**MINUTES OF THE MEETING  
June 19, 2008**

**Seattle  
Design  
Commission**

**Project: 1200 Stewart**

**Phase: Alley Vacation**

**Figure 1: Current building design**

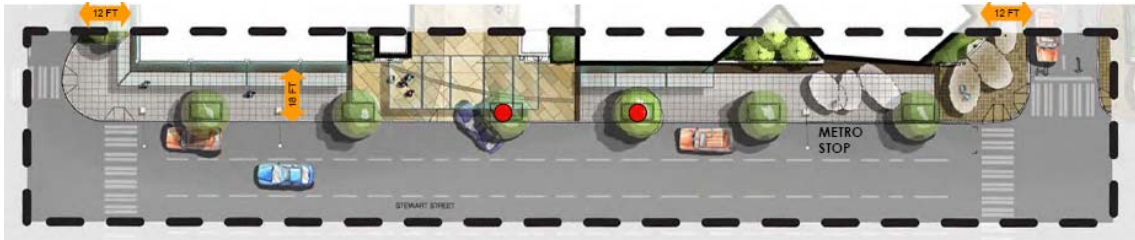
- **The base of the building appears rather massive and not very porous. Consider using smaller forms, lowering the scale to a pedestrian level and increasing functional and visual connections through this development.**

- **More design attention needs to be paid to the service area, the blind façade portion of the corner and the relationship with the public realm, as well as the retail on the Yale corner and the relationship to the Metro stop.**

- **We encourage further exploration of the sidewalk garden areas on both corners of Denny.**
- **We encourage the design team to clarify the character of the “Main Gate” element on Denny, which incorrectly suggests it is the principal entrance. This reference is not consistent and might create a wayfinding conflict with a drop off area, pedestrian circulation and public space.**

**Figure 3: Improvements at Denny and Minor**

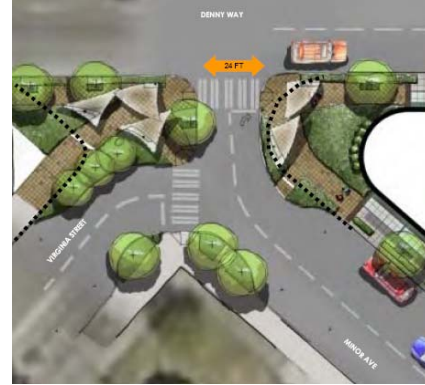
- **Consider `consolidating the driveways and curb cuts on Minor. The Commission appreciates the narrowing of the pedestrian crossing on Minor and Yale, as well as the bulb-outs and buffer on Denny Way.**

- Haven't reviewed the traffic revision at the corners, but the concept has been received positively.
- Reducing the crossing distance is a priority.
- Stewart will be a peak hour transit lane, and could be replaced with a permanent transit lane.
